**MODIFICATION REQUEST TO CONCEPT
APPROVAL AND STATE SIGNIFICANT
DEVELOPMENT ASSESSMENT REPORT:**

**Concept Approval MOD 10
SSD Application for Block 4N**

Central Park (former Carlton United Breweries site)

MP 06_0171 MOD 10 and SSD 6673

Figure 7: Comparison between the Concept Approval (left) and the proposed (right) building envelopes highlighting increases (pink/orange) and reductions (blue) (Source: applicant's application)

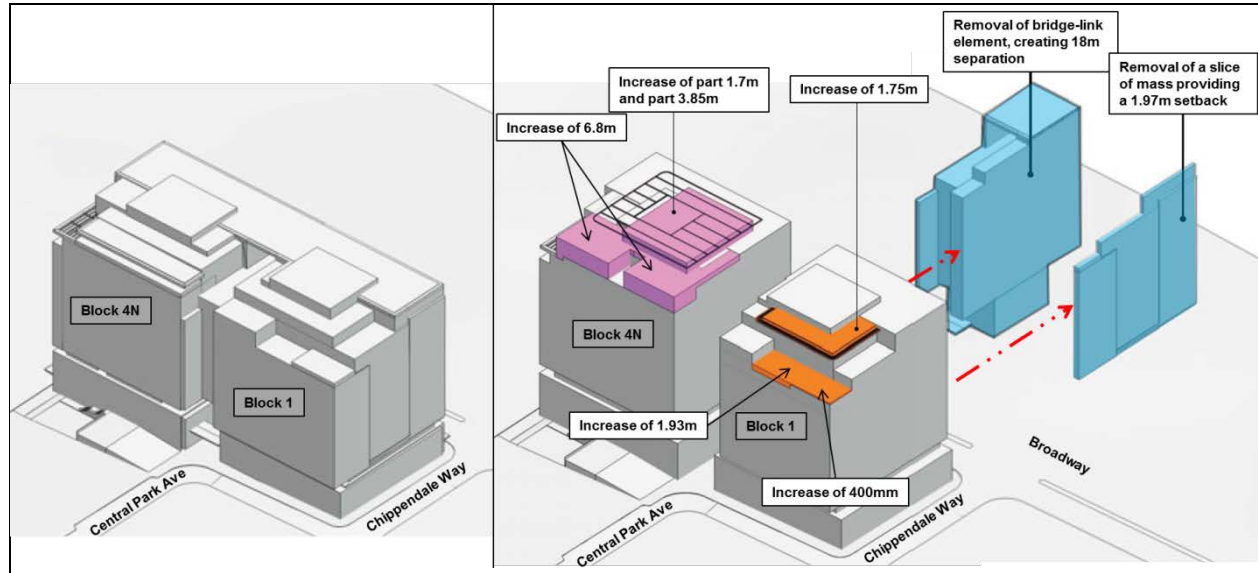
The proposed modifications to Blocks 1 and 4N building envelopes include:

- the provision of a setback on the eastern elevation of Block 1 fronting Chippendale Way will provide for a minimum separation distance of 24 metres to the neighbouring residential building at Block 2;

- the increase in building height at Block 4N maintains the an appropriate transition to the neighbouring Blocks 4S to the south and Block 1 to the east and will provide for a building of appropriate stature at this prominent intersection / corner location;

- the increase in building envelope height to the rear of Block 1 is minor and would not result in a noticeable increase in bulk or scale when viewed from the surrounding streets or open space; and

- the shadow analysis submitted with the application has demonstrated that the revised building envelopes allow for improved solar access to the immediate surrounding public domain, compared to the approved envelopes.

Figure 8: The location of the proposed short term car parking (Base source: MP06_0171 MOD9 and applicant's RtS)

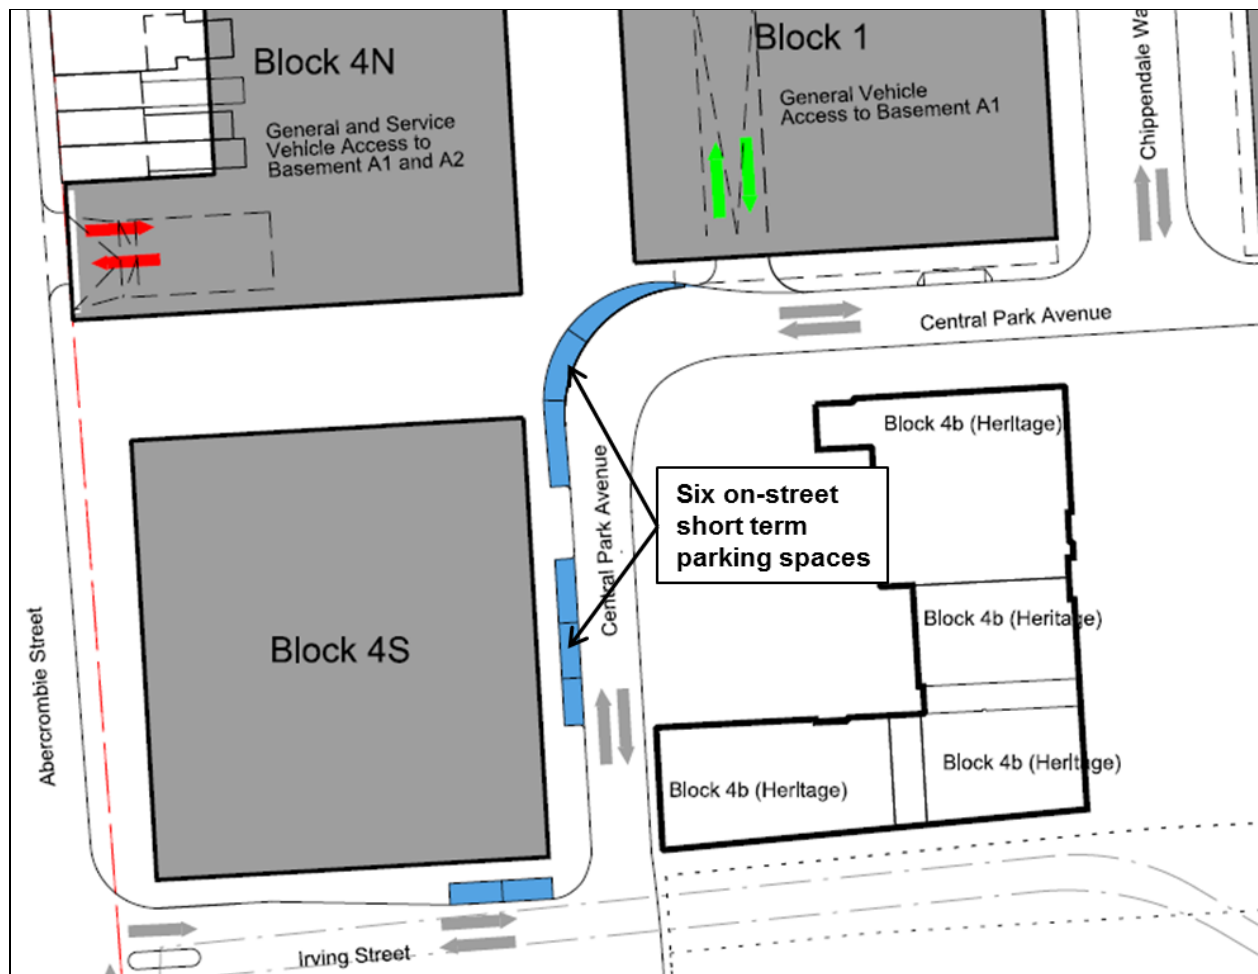
The proposal includes the provision of six on-street short term (15 minute) car parking spaces, three spaces located at the bend of Central Park Avenue and three spaces located outside the eastern frontage of Block 4S. The six short term spaces will be pick-up / drop-off spaces relating

to the childcare facility and will also be capable of accommodating a 7.7 metre long (25 seater) coach for the hotel (refer to **Figure 8**).

Council raised concerns with the number and location of the proposed additional car parking spaces. Specifically, Council stated that the number of spaces may be insufficient for the likely pick up / drop off requirements of the childcare facility and the hotel. Council also questioned the safety of the parking spaces situated on the curve of Central Park Avenue and ability of garbage trucks to manoeuvre around the bend of Central Park Avenue. Council also advised that adequate footway widths must be provided and the parking will need to be referred to the Local Pedestrian, Cycling and Traffic Calming Committee (LPCTCC).

The applicant has stated that the six proposed short term parking spaces are sufficient for the development as the client base for the childcare facility is likely to be local and within walking distance and also as the site is well served by public transport. The applicant submitted swept path analysis, which demonstrates that the pick up / drop off parking spaces located on the bend of Central Park Avenue can be used safely by cars and/or a small coach (a 7.9m long, 22 seater coach) and that garbage trucks can safely manoeuvre around the corner of Central Park Avenue when the short term parking spaces are in use (refer to **Figure 9**).

The Department notes that Council's Development Control Plan (DCP) 2012 recommends that childcare centres be provided with one pick up / drop off parking space per eight children, which equates to nine spaces for the proposal. However, the DCP outlines that the parking rate may be reduced having regard to the site's accessibility by walking and public transport. Council's DCP advocates a merit based assessment of coach parking requirements for hotel developments and does not specify a maximum or minimum coach parking rate.

Figure 10: Abercrombie Street frontage, including the Australian Hotel and adjoining terraces, vehicle entrance and through site link (Base source: applicant's EIS)

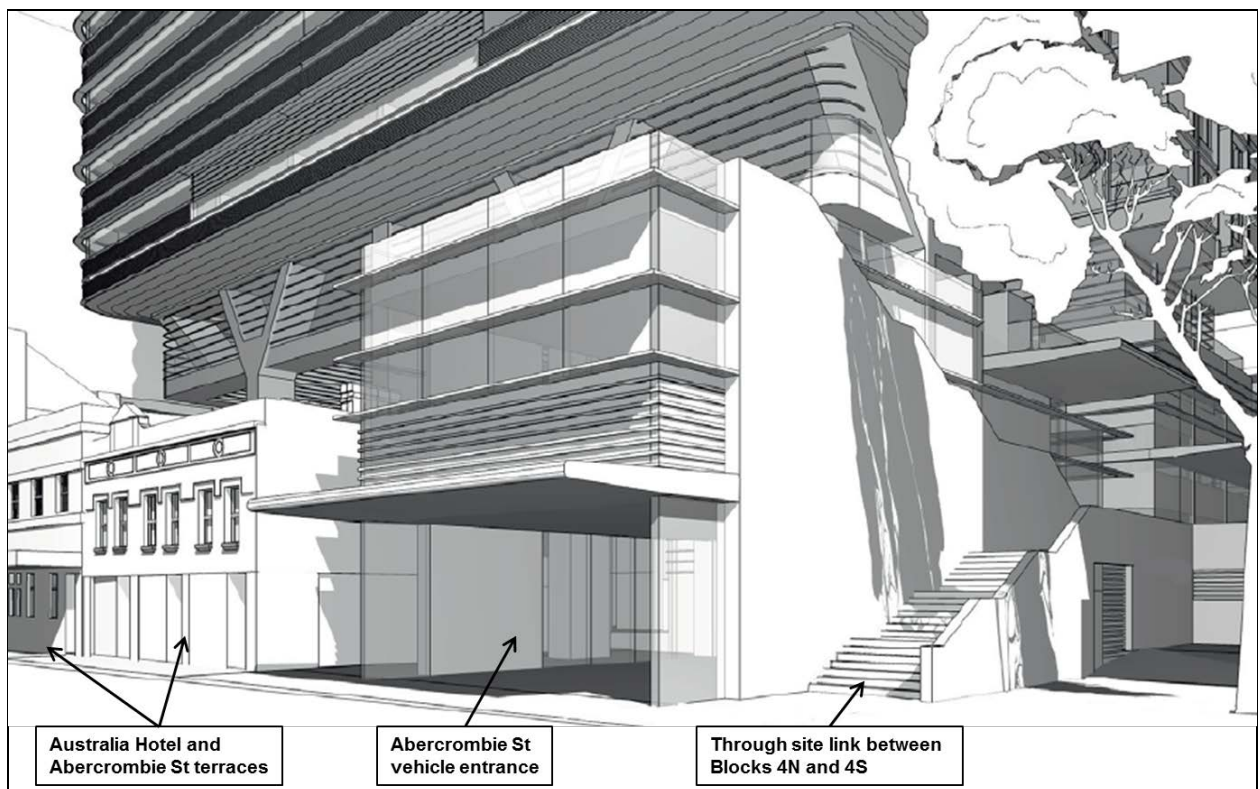
Future Assessment Requirement B1 of the Concept Approval requires that the SSD application consider the resolution of the form and bulk of buildings along Abercrombie Street to ensure compatibility with the scale of buildings in the area and to maintain visual links into and outside the site, particularly to heritage items. Further, Modification A9 requires that the development provide for an appropriate elevation to Broadway and Abercrombie Street in order to protect the heritage significance of the heritage items.

The applicant contends that development has sympathetically incorporated the heritage items into the overall design of the development as:

- the massing of Block 4N (office/residential component) provides for a generous setback from Abercrombie Street and allows the heritage items to be appreciated without being overwhelmed by the new development;
- a publicly accessible courtyard is provided behind the heritage items, which is accessed from Abercrombie Street and Broadway; and
- a three storey building is provided to the south of the Abercrombie Street terraces enclosing the vehicular entrance to Block 4N (the Entrance Building) and screening it from view (refer to **Figure 10**).

Concerns were raised in the public submission that:

- the retained heritage items and the Entrance Building provide a defined street wall to the Abercrombie Street frontage;
- the Entrance Building:
 - is one storey higher than the Abercrombie Street terraces and one storey lower than the neighbouring podium of Block 4S and therefore provides a suitable built form transition between Block 4S and the Abercrombie Street terraces;

Figure 11: Typical residential floor layout and residential building depth (Base source: applicant's RtS)

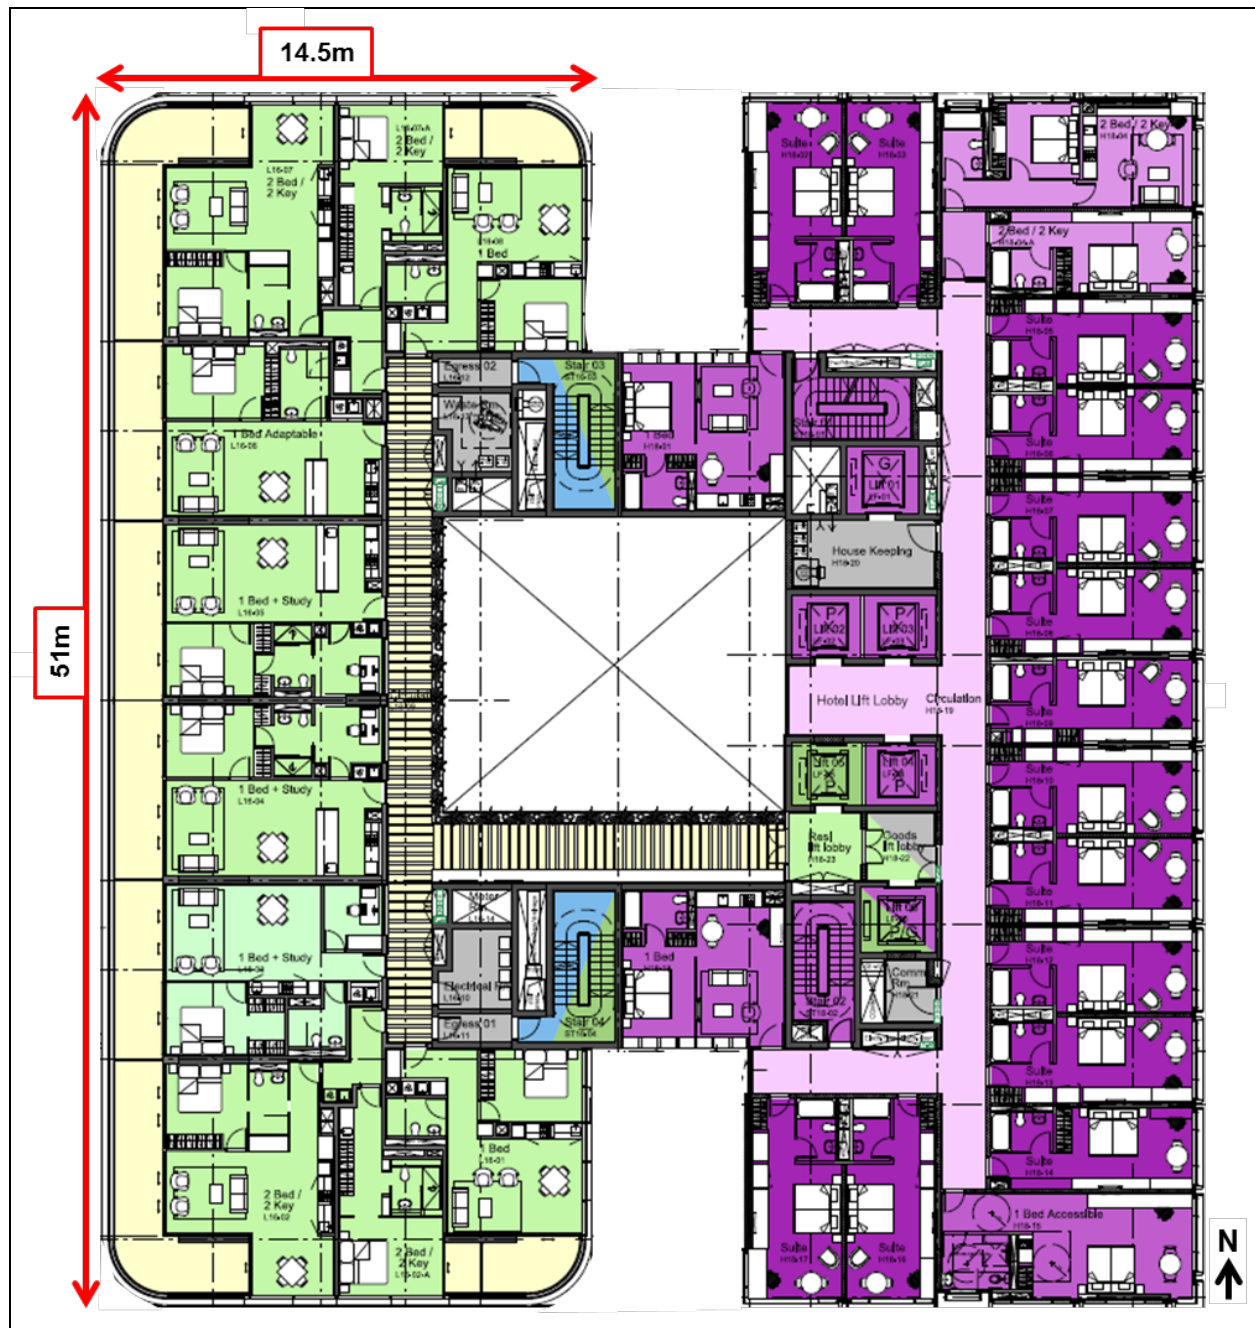
The proposed residential component of Block 4N (48 residential apartments) is limited to the western half of the building between levels 11 to 16 (refer to **Figure 11**)

The Department has assessed the amenity impacts of the proposal against *State Environmental Planning Policy No. 65 (Design Quality of Residential Flat Buildings)* (SEPP 65) and the accompanying *Residential Flat Design Code* (RFDC). The Department has also considered the relevant amenity criteria within the recently endorsed SEPP 65 (Amendment no.3) and accompanying *Apartment Design Guide* (ADG), which replaces the RFDC. The Department has applied the RFDC guidelines and ADG criteria in the knowledge that only a small proportion of the development is in fact residential and can therefore not be reasonably expected to meet the design requirements intended for a (predominantly) residential building.

Figure 12: Excerpt of level 11 indicating the separation between residential and hotel uses within Block 4N and separation of Block 4N and Block 1 (Base source: applicant's RtS)

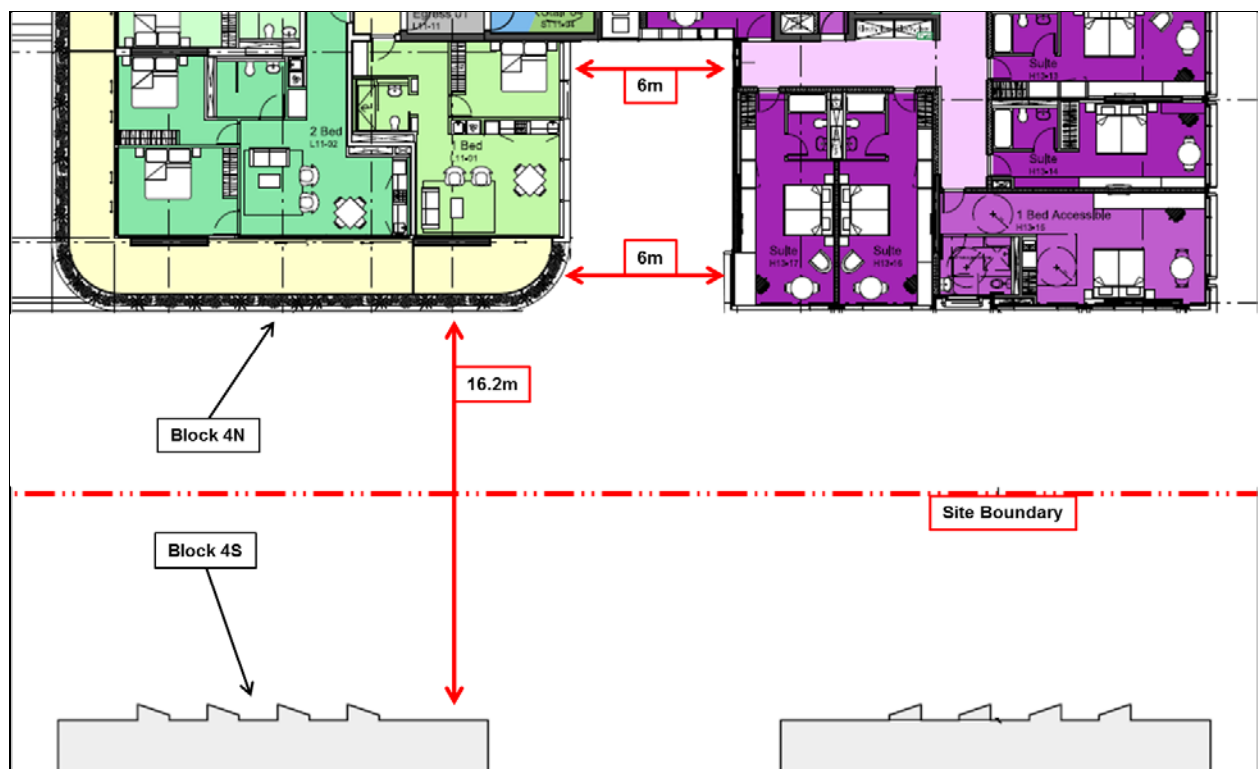
The proposed Block 4N building is separated from neighbouring Block 1 (to the east) by 20.5 metres and from Block 4S (to the south) by 16.2 metres. Six metre separation is provided between the hotel and residential components of the building (refer to **Figure 12**).

The 20.5 metre separation distance between the eastern elevation of Block 4N (hotel use) and the western elevation of Block 1 (residential use) exceeds the 18 metre minimum required by the Concept Approval and the RFDC and ADG and is therefore acceptable.

The six metre internal separation between the residential and hotel components is less than the 18 metres recommended by the RFDC and ADG. As a result of the limited separation, apartments on levels 11 to 16 may be affected by hotel suites and an internal corridor window directly opposite as shown at **Figure 12**. To ensure that the affected apartments are afforded an appropriate level of privacy, the Department recommends a condition that requires the hotel circulation corridor windows and hotel suite windows at each level be treated/screened.

Figure 13: Internal residential courtyard layout (left) and solar access (right) (Base source: Applicant's EIS and RtS)

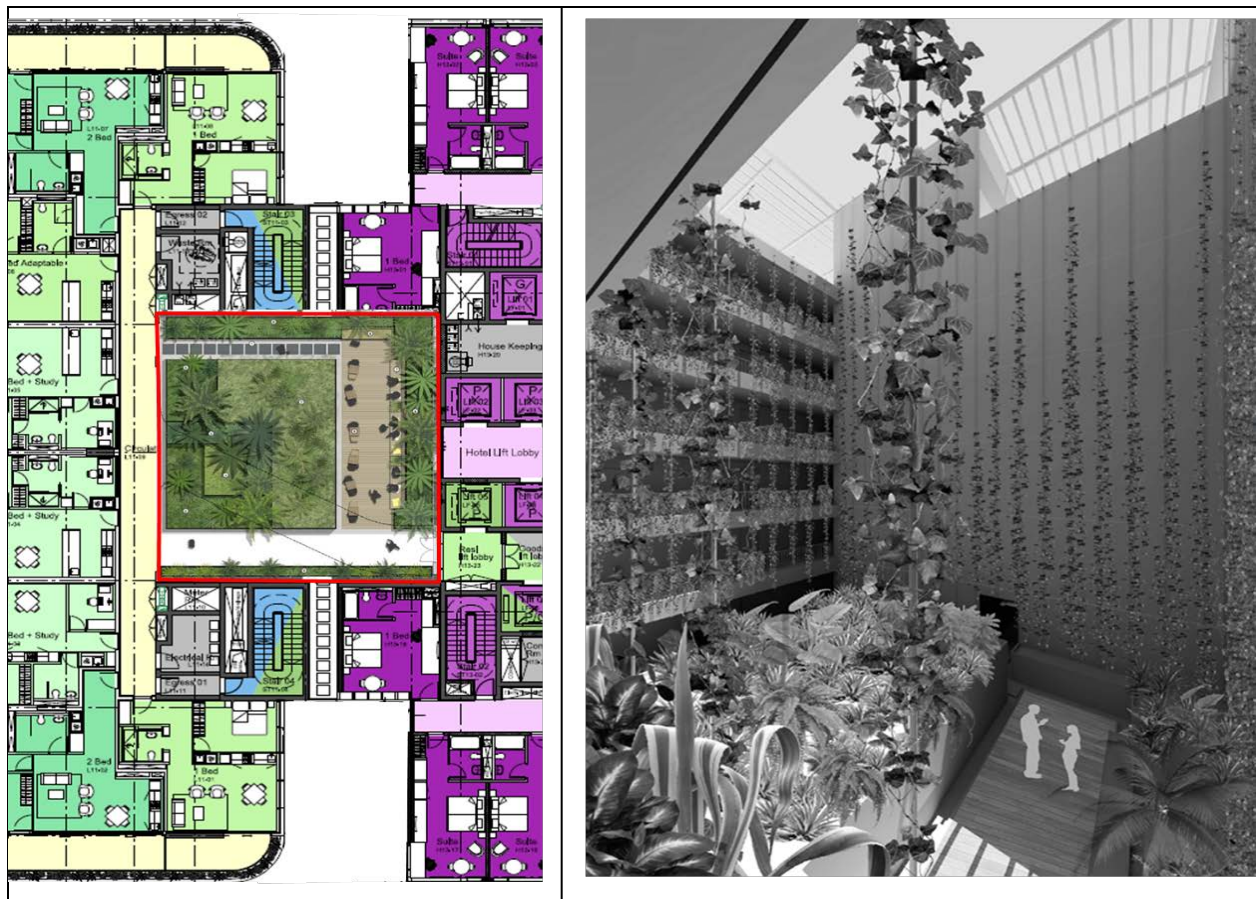
A total of 132m² residential communal open space is provided, in the form of an internal residential courtyard, at residential level 11. This equates to approximately 3.2% of the overall site area or 6.4% of the western portion of the site where the residential component is situated (refer to **Figure 13**).

The Department notes that the ADG states that variations to the percentage of communal open space are possible for sites with high site coverage or in a centre on the basis of increased private open space / balconies and/or good access to public open space and/or contributions to public open space.

While the overall amount of communal open space is less than recommended, Block 4N is near to Chippendale Green, which is a 6,000m² park provided by the applicant as part of the Concept Approval, and available for the use of residents, employees and the local community. In addition, apartments are provided with private open space in accordance with the objectives of the RFDC / ADC with a minimum depth of 2 metres. Given the context of the site and its closeness to Chippendale Green, the private open space provided to residents is acceptable.

Figure 14: A dual key apartment (outlined in red) and the internal division between the studio and one bedroom apartments within (outlined in yellow and blue) (Source: applicant's RtS)

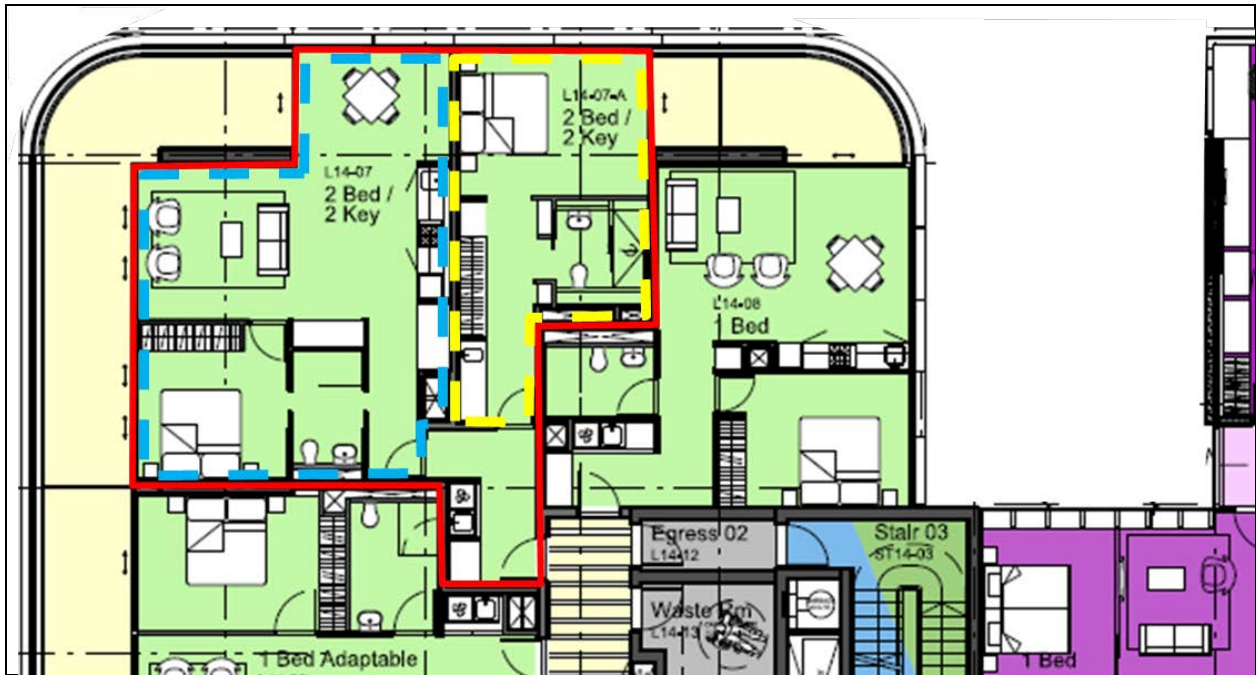
The proposal seeks approval for a total of 10 two bedroom dual key apartments, each containing a studio and a 1 bedroom apartment. **Figure 14** illustrates a typical proposed dual key apartment. The proposed internal layout provides two dual key apartments on each floor between residential levels 12 and 16, located at the northern and southern ends of the building. The apartments are all dual aspect and have opportunities for solar access and views across the roof of Block 4S or towards the CBD.

The RFDC does not address dual key apartments. The ADG acknowledges that dual key apartments provide flexibility in tenancy and housing choice however there is no guidance in relation to design or amenity for these types of apartments. The Department has previously assessed the suitability of the residential amenity of dual key apartments in other approvals within the Central Park precinct and concluded that dual key apartments would provide an adequate level of amenity where they:

- are provided with private open space; and / or
- are provided with cross flow ventilation; and / or
- receive more than 2 hours of sunlight access; and / or
- are provided with an outlook.

In order to ensure that an adequate level of amenity is provided to each apartment (especially if the apartments are rented or occupied separately), the Department has applied the above noted criteria, consistent with other assessments of dual key apartments on the Central Park precinct.
